RESPONSE DOCUMENT

FOR THE SMITH BAY WHARF DRAFT EIS AND ADDENDUM

Part One:	KIPT Response and Conclusions	2
Part Two:	Responses to Submissions	22
Part Three:	Appendices	475

Figure 1: Figure 3-2 Revised concept design for the KI Seaport

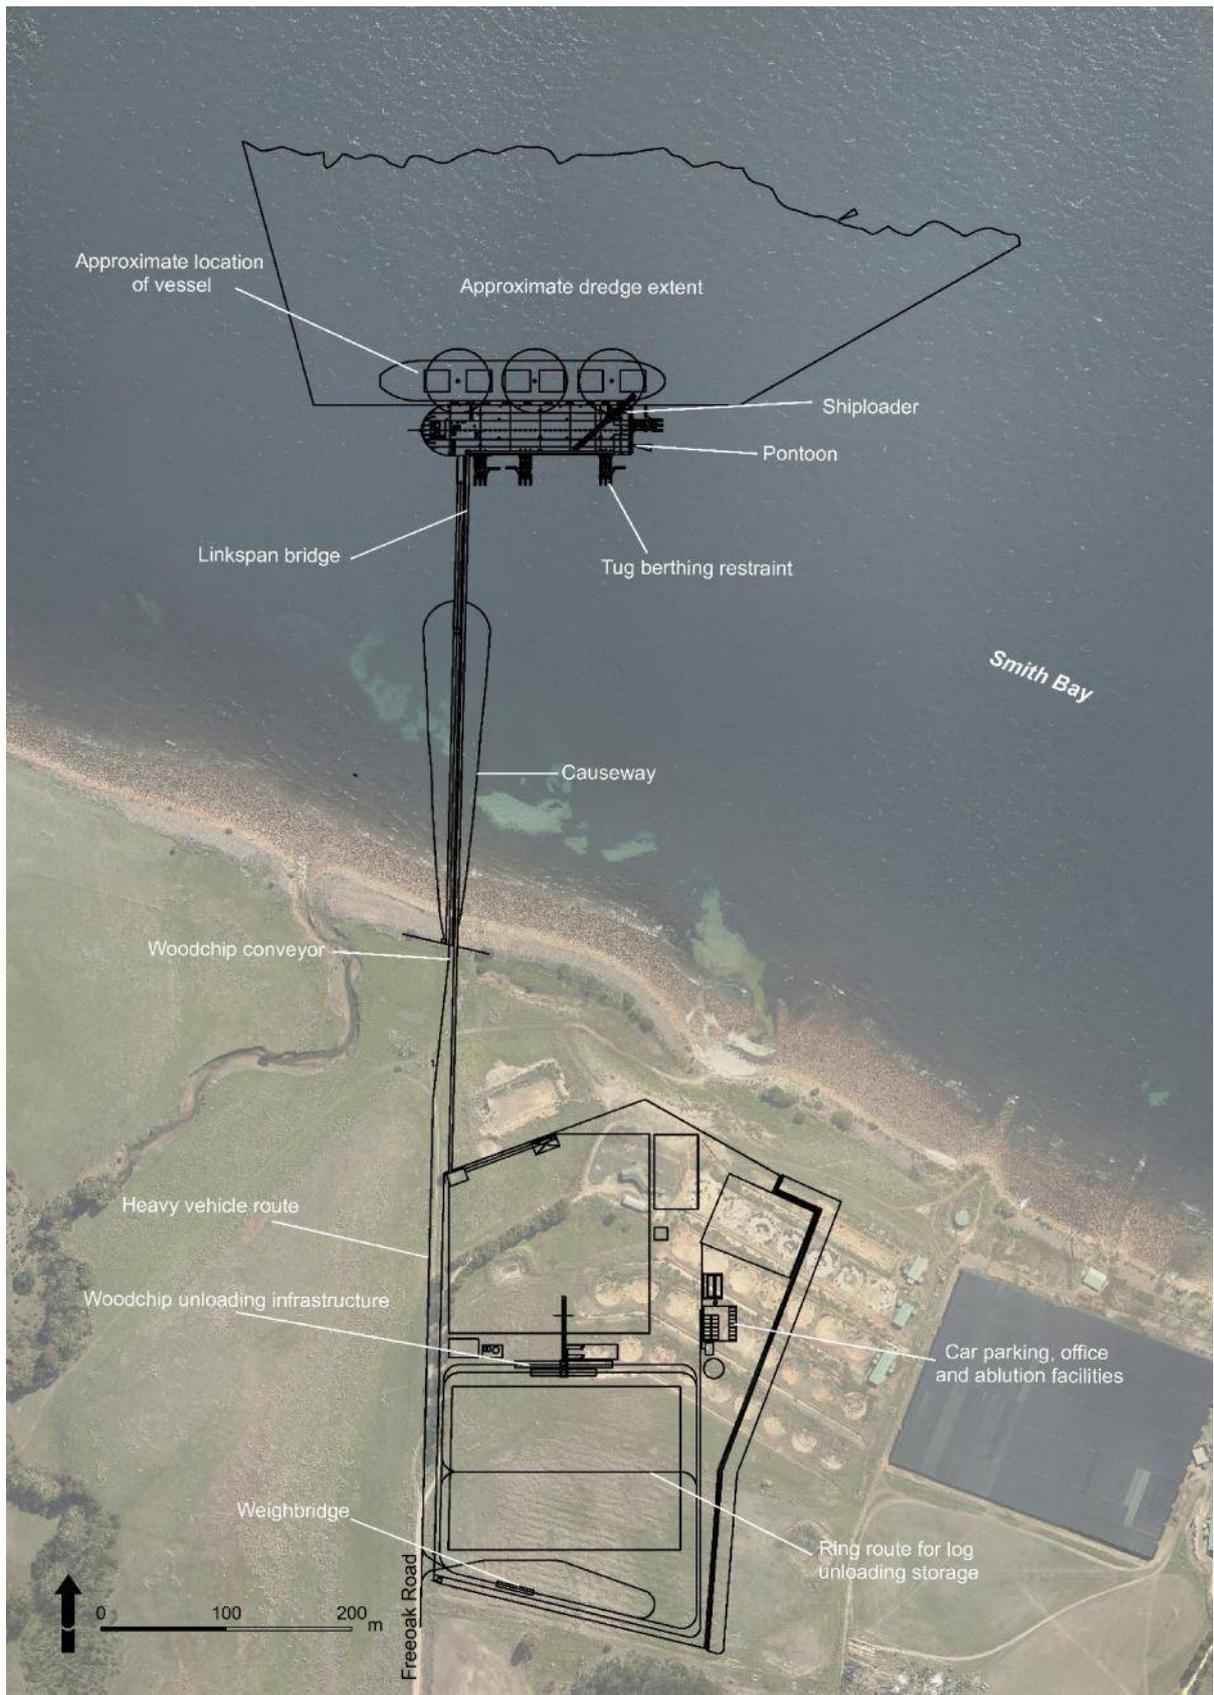
Draft EIS section	Submission ID	Issue	Alteration
Figure 3-2 Revised concept design for the KI Seaport		<ul style="list-style-type: none"> Label annotation reads ‘Dolphin restraint’ instead of ‘Tug berthing restraint’ Label annotation for ‘Woodchip unloading infrastructure’ is omitted in the Draft EIS Label annotation ‘Office and ablution facilities’ was omitted on car park label 	<p>‘Dolphin restraint’ annotation has been changed to ‘Tug berthing restraint’</p> <p>Label annotation for ‘Woodchip unloading infrastructure’ has been added</p> <p>Label annotation for ‘Office and ablution facilities’ on car park label has been added</p>
Figure 4-3 Conceptual layout of the KI Seaport infrastructure		Label annotation reads ‘Tug berthing/dolphin restraint’ instead of ‘Tug berthing restraint’	Dolphin restraint’ annotation has been changed to ‘Tug berthing restraint’
Figure 11-2 Yumbah abalone farm facilities in relation to the proposed KI Seaport		Freeoak Road is labelled incorrectly as Unnamed Road	Label annotation for the access road to Freeoak Road has been added.

Figure 4: Figure 12-2 Existing habitat mapping for the central north coast of Kangaroo Island

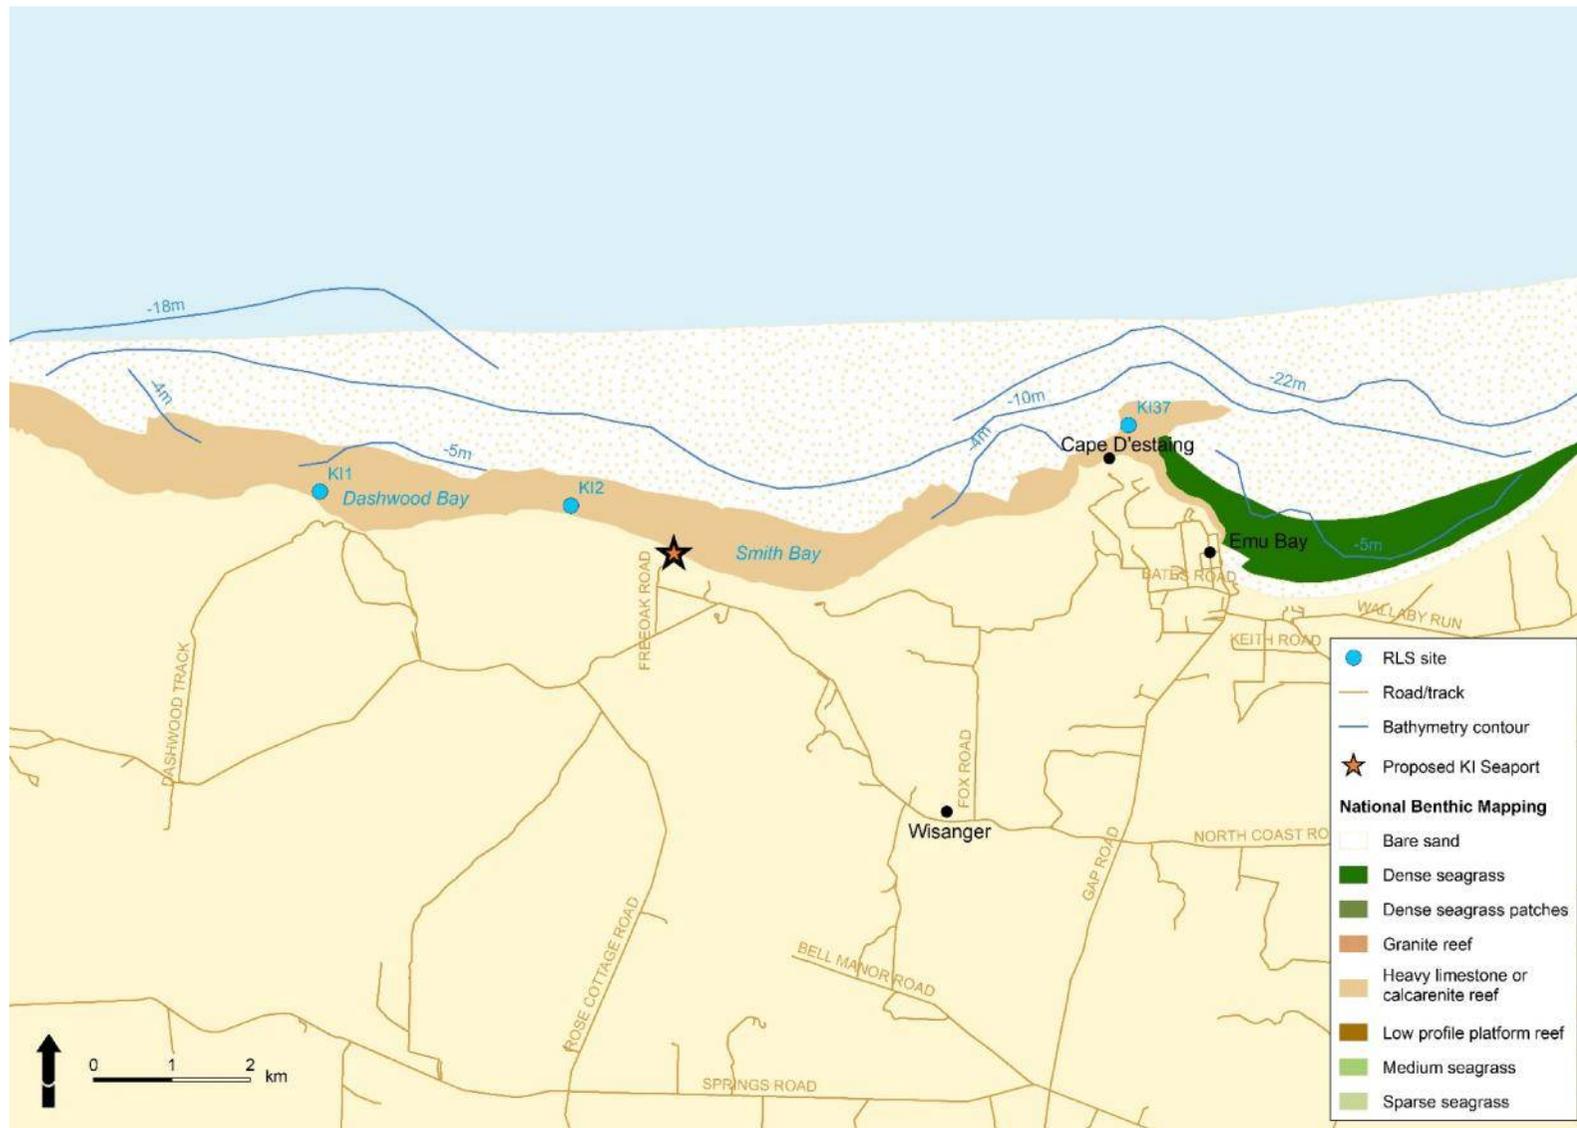
Draft EIS section	Submission ID	Issue	Alteration
Figure 12-2 Existing habitat mapping for the central north coast of Kangaroo Island		Freeoak Road is labelled incorrectly as Unnamed Road	Label annotation for the access road to Freeoak Road has been added.
Figure 16-2 Regional contours map		Missing text	Label annotation for 'Fox Road' has been added.
Figure 16-8 Groundwater grab sample locations		Symbolisation of GW2 should be "Inspection point liquid grab sample".	GW2 symbology has been changed from "Groundwater grab sample location" to "Inspection point liquid grab sample".
Figure 16-9 Site contours (m RL) map		Missing text	Label annotation for the access road to Freeoak Road has been added.
Figure 17-1 Conceptual layout of the proposed KI Seaport		<ul style="list-style-type: none"> Label annotation reads 'Dolphin restraint' instead of 'Tug berthing restraint' Label annotation for 'Woodchip unloading infrastructure' is omitted in the Draft EIS Label annotation 'Office and ablution facilities' was omitted on car park label 	<p>'Dolphin restraint' annotation has been changed to 'Tug berthing restraint'.</p> <p>Label annotation for 'Woodchip unloading infrastructure' has been added.</p> <p>Label annotation for 'Office and ablution facilities' on car park label has been added</p>

Figure 9: Figure 21-8 KIPT's selected route

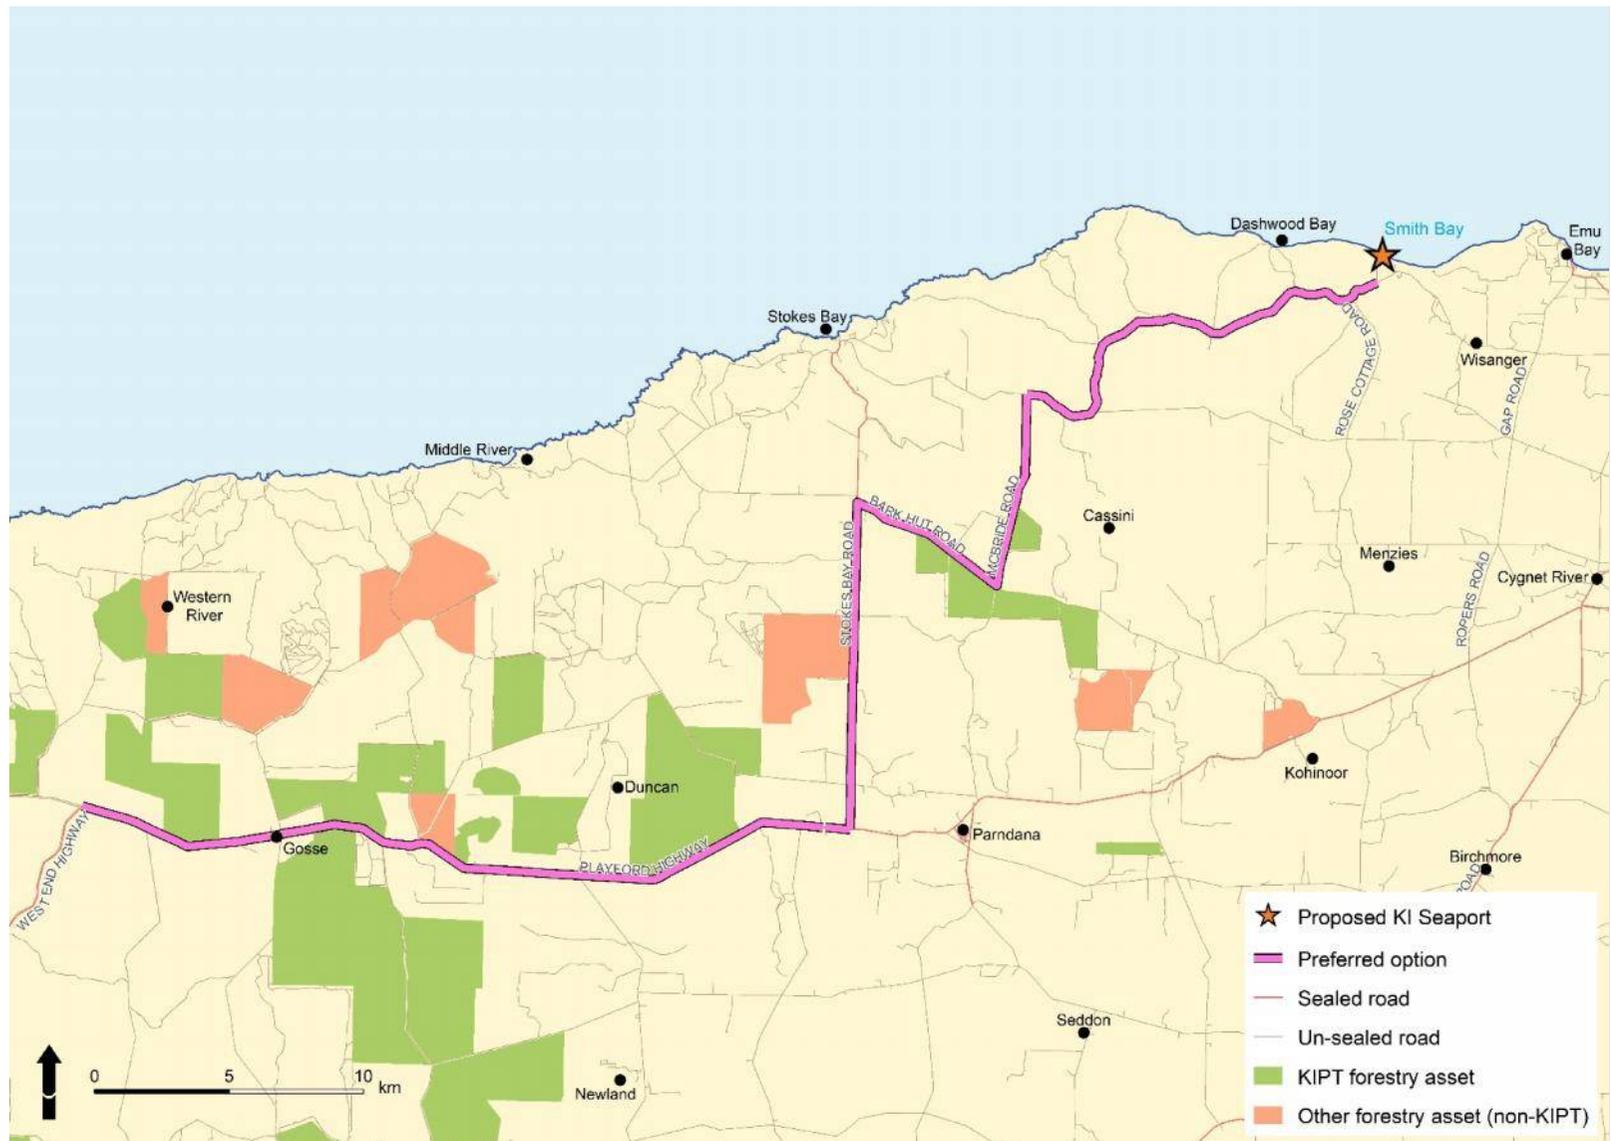
Figure 21-8 KIPT's selected route		The boundary of the shoreline for Kangaroo Island does not align with the land mass. Transport route is separated in places and does not reach site. Site location (star) is not correct	Shoreline boundary aligns correctly to the Kangaroo Island shoreline. Transport route is now fully connected and site location is in correct position.
Figure 21-11 Proposed Marine Activity Zone		Label annotation reads 'Dolphin restraint' instead of 'Tug berthing restraint'	'Dolphin restraint' annotation has been changed to 'Tug berthing restraint'.
Figure 11. Figure 21-12 Conceptual temporary exclusion zone layout when vessels berthed		Missing 25 m arrows as shown in Figure 4.16 Label annotation reads 'Dolphin restraint' instead of 'Tug berthing restraint'	<p>Arrows have been added.</p> <p>'Dolphin restraint' annotation has been changed to 'Tug berthing restraint'.</p>
Figure 24-1 Timeline of settlement on Kangaroo Island	AAR 9 (2)	Flowchart incorrectly states when Aboriginal occupation of Kangaroo Island ceased.	<p>Annotation has been deleted.</p> <p>Additional reference material (Draper 2015) indicates that there was Aboriginal occupation of the Island as recently as 350-400 BP. This is reflected in the updated EBS desktop heritage assessment (Appendix G).</p>
